a) sAOD (500 nm) trend from 2001 to 2010

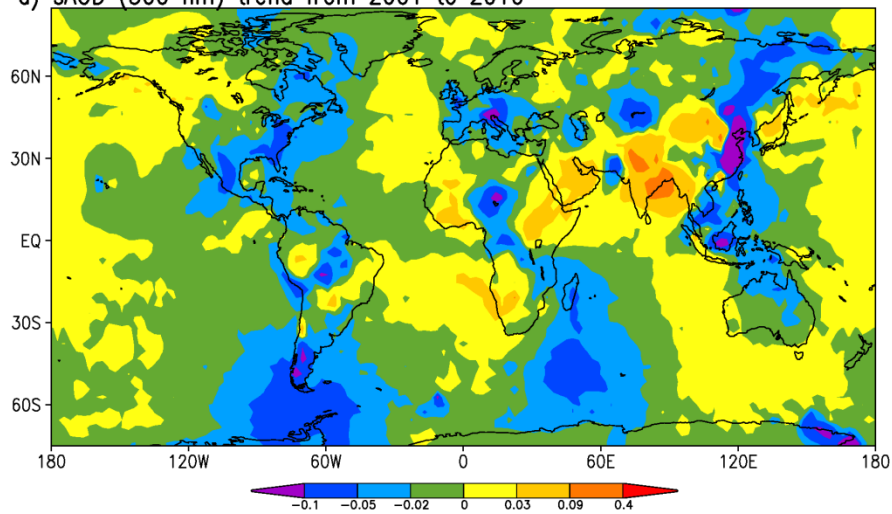
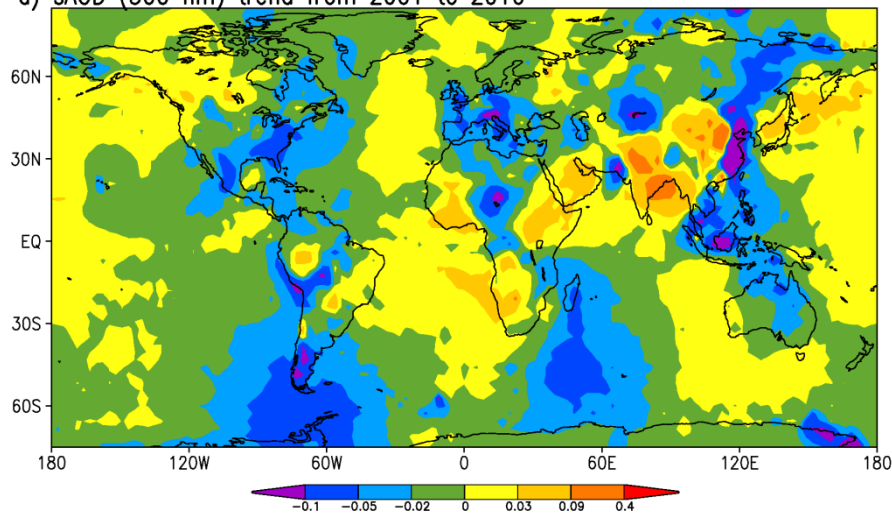
We thank you for your valuable input. As we address the issues raised by you, we will better understand the uncertainties of the estimates we provide. We also feel that some of the issues you raised came from an insufficient understanding of our manuscript, in which case, we still need to revise our paper to better explain the points. For example, our best estimate of sAOD (which is from integrating the MODIS, MISR and AERONET data) is able to reproduce the AERONET sAOD with an overall error of $13\pm 2\%$, when the AERONET sAOD used for the validation is not used for the best estimate. This means that even if there is no AERONET station in some area our sAOD estimate is accurate in that area with an error of 13%. To demonstrate this, we conducted a sensitivity study as below.

As you can see, our sAOD trend does not depend too much on the AERONET data. Of course, the accuracy improves with AERONET data. We believe that generating a reliable estimate of global sAOD (over both the ocean and the land) is a significant advance. To demonstrate the accuracy of our estimate, we need to convince skeptics like you. This is why we appreciate your criticism and as a result of addressing your points we will strengthen the paper. We will address all of your issues and revise the paper.
